RL-207 Reeling Machine...

UPGRADE THE ENGINE

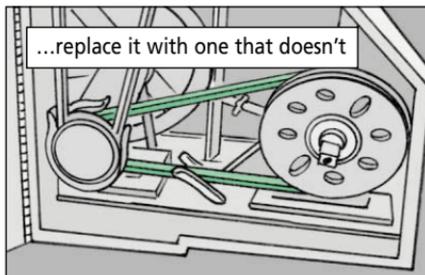
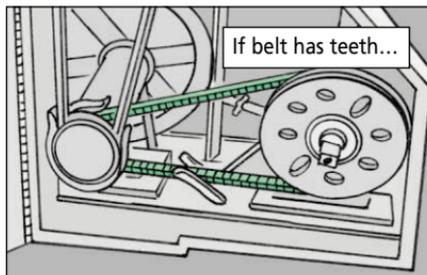
The Mil-Std engine for the RL-207 reeling machine, NSN 3895-00-892-4583, has been replaced with NSN 2805-01-169-1100.

Check the engine data plate. If you have part number 2A016-4, you have the upgraded engine. If you have part number 2A016-1, -2, or -3, order the new engine when you need to replace the old one.

While you're looking at the engine data plate, check out the upper and lower V-belts. Both of these belts should be smooth—no teeth. If you have one with teeth, replace it. It could grab and cause injury or equipment damage. NSN 3030-01-290-1371 brings the upper belt. NSN 3030-01-158-7527 brings the lower belt.
